September 20, 1983

The Commission has issued the enclosed Amendment No. 74 to Facility Operating License No. DPR-58 for the Donald C. Cook Nuclear Plant, Unit No. 1. This amendment consists of changes to the Technical Specifications in response to your application transmitted by letter dated May 11, 1983, as supplemented by letter dated July 25, 1983.

This amendment approves the Cycle 8 reload and changes the related Technical Specifications. The Cycle 8 reload includes Westinghouse fuel of the 15 x 15 Optimized Fuel Assembly design with fuel enrichments up to 4.0 weight percent U-235, fuel burnups to 39,000 MWD/MTU, and Wet Annular Burnup Assembly (WABA) burnable poison absorbers.

Amendment No. 74  
License No. DPR-58

FIGURE 2.1-1 REACTOR CORE SAFETY LIMIT  
4 LOOPS IN OPERATION

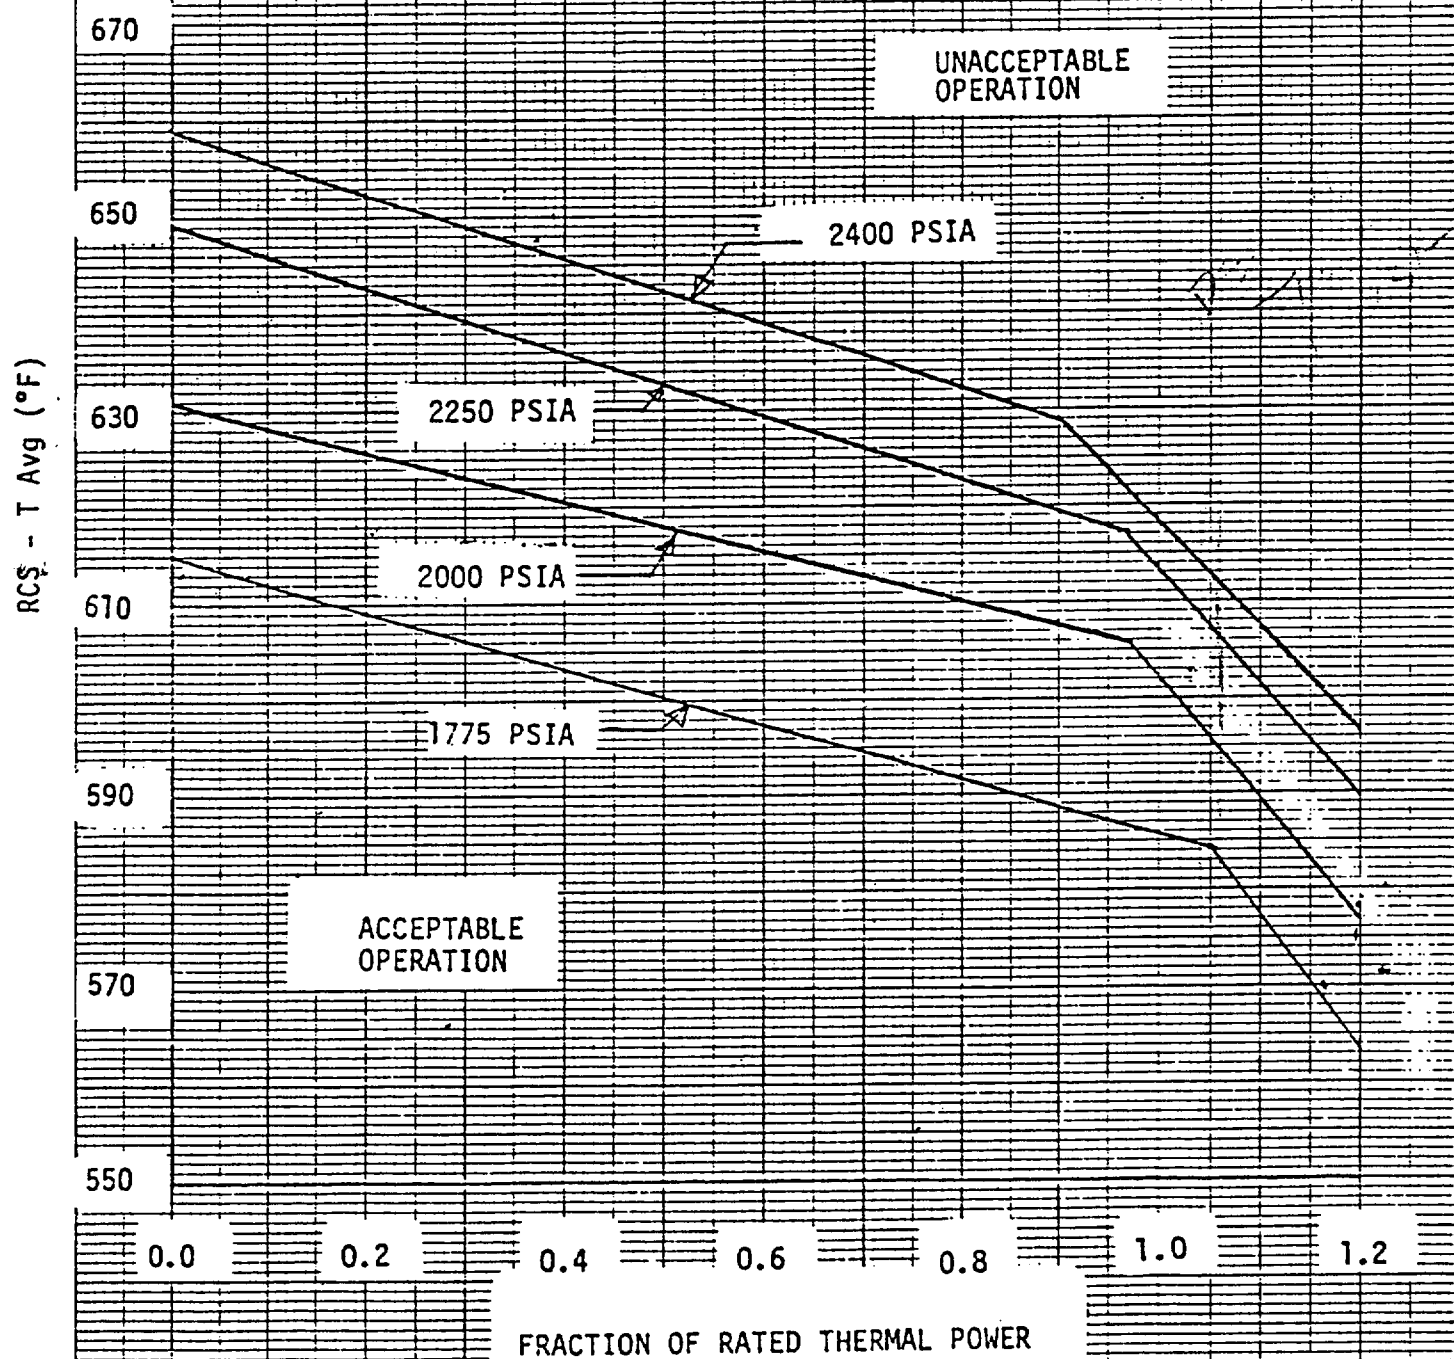
This figure provides the low points of the thermal power, RCS pressure and average temperature as reactor core safety limit for 4-loop operation to avoid violation of the design DNBR limit using the improved thermal design procedure. This figure is identical to Figure 3 of the Attachment C to AEP:NRC: 07450 in which the "fraction of design thermal power" is used in the abscissa and a conversion factor of (design thermal power/rated thermal power) is needed to convert the abscissa to "fraction of rated thermal power".

FIGURE 3.1-1 ROD GROUP INSERTION LIMITS VERSUS THERMAL POWER  
3 LOOP OPERATION

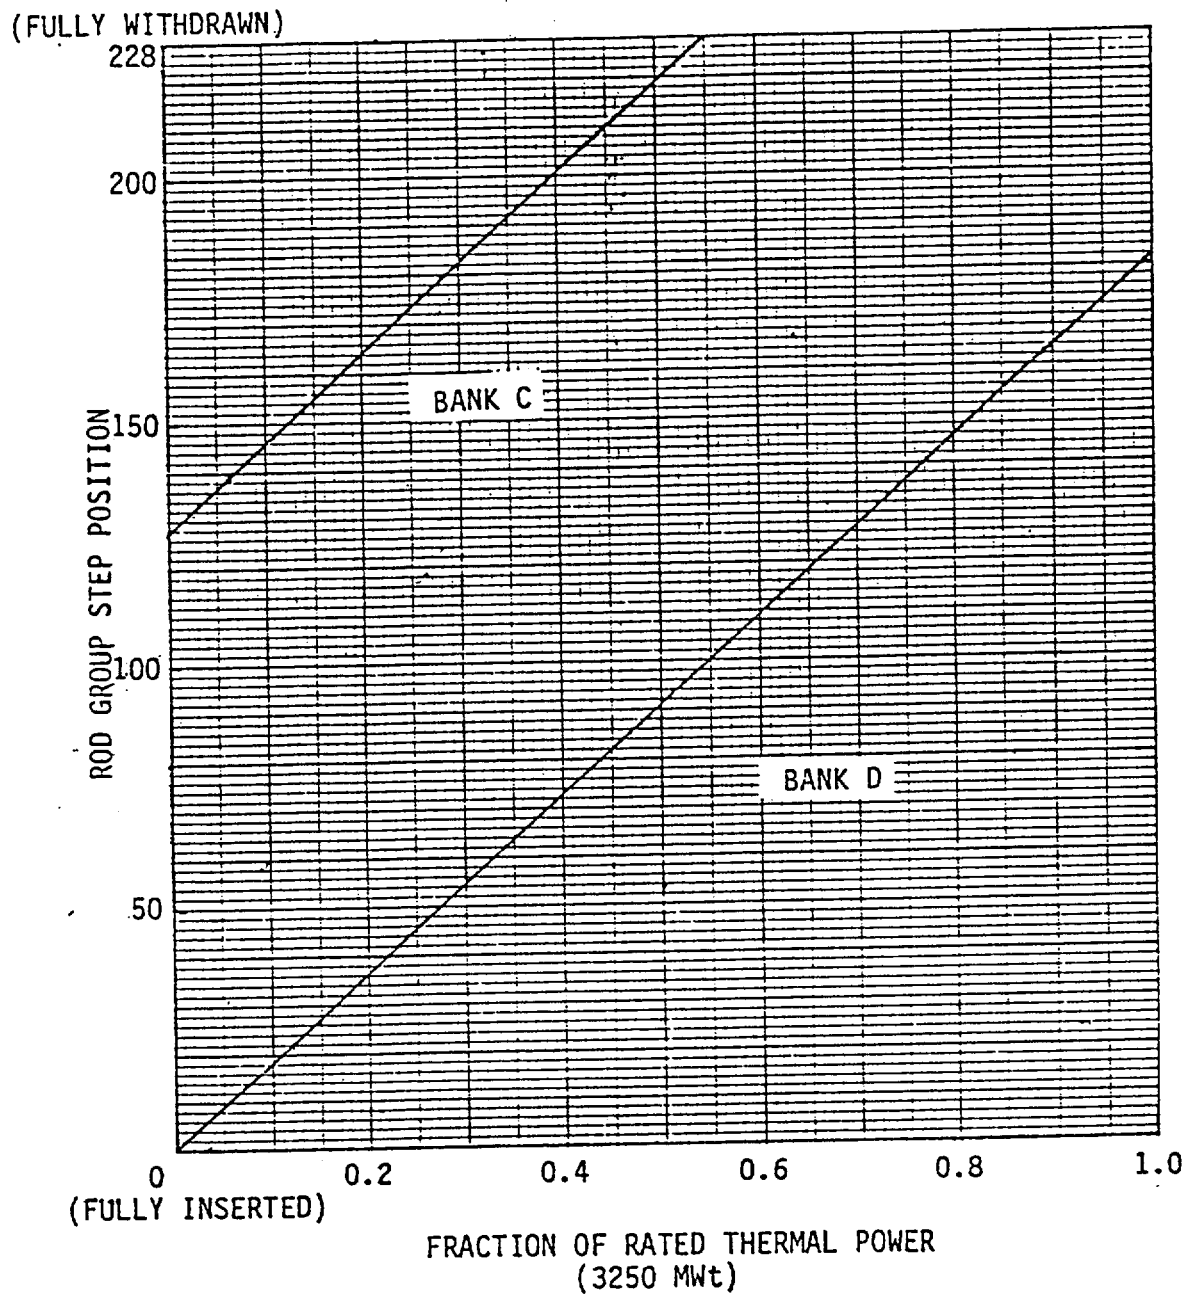
These figures show the rod group insertion limits for three-loop and four-loop operation respectively. Since these were obtained by using standard Westinghouse methodology we conclude that they are acceptable.
